**CERTIFICATE OF APPROPRIATENESS**

**Property:** 1028 Arlington Street, Lot 21, Block 220, Houston Heights Neighborhood Subdivision. The property includes a historic 2,198 square foot, two-story wood single-family residence and a 737 sq. ft. detached, two-story pool house situated on a 6,600 square foot (50' x 132') interior lot.

**Proposal:** Enclose existing rear porch and make into conditioned space

Current Photo Provided By Applicant

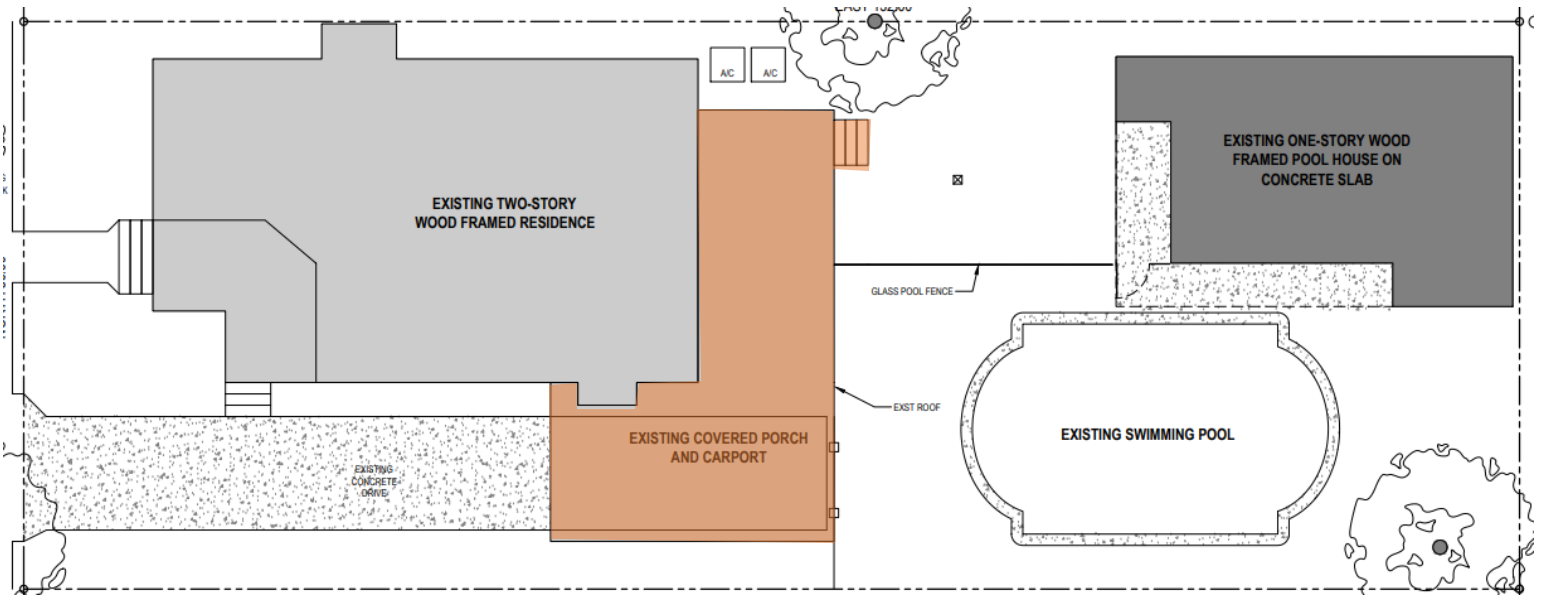
Area shaded in orange is rear, open porch to be turned into enclosed, conditioned space

Proposed Site Plan

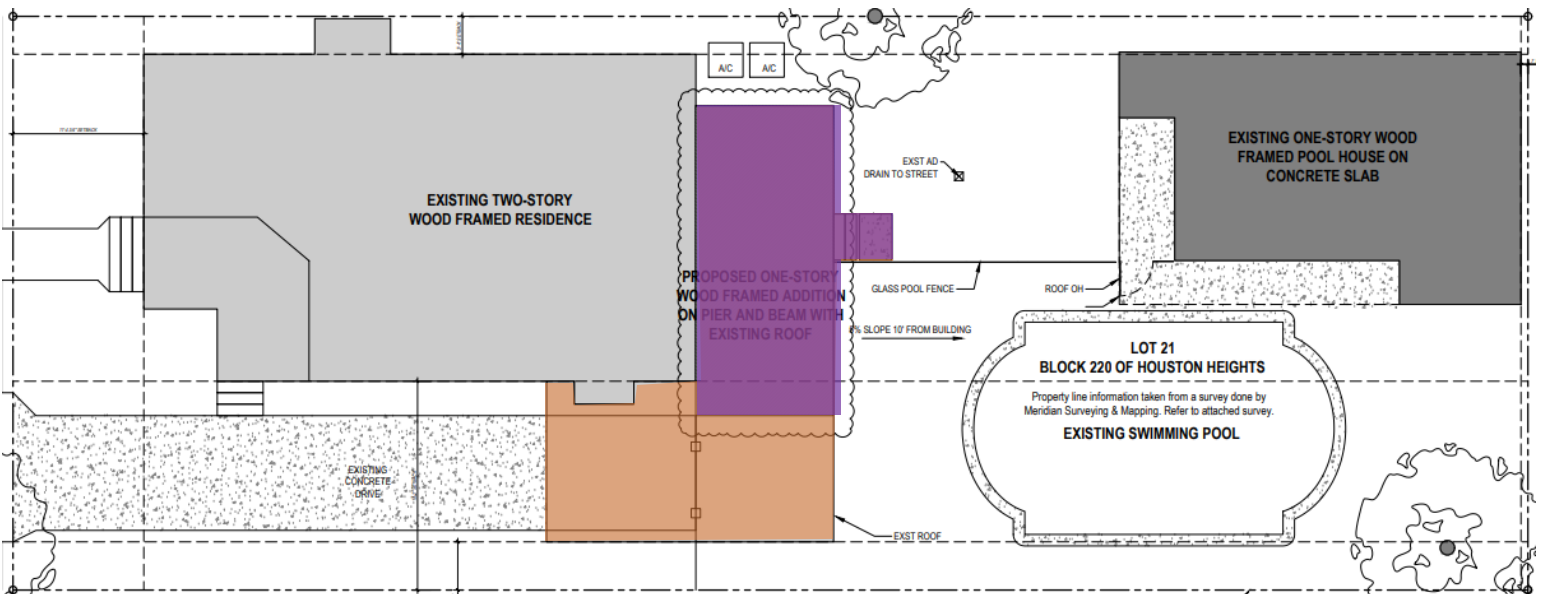
Area shaded in orange is the carport and roof of rear porch that will change from composition shingles to standing seam metal. Area shaded in purple is rear porch converted into conditioned space.
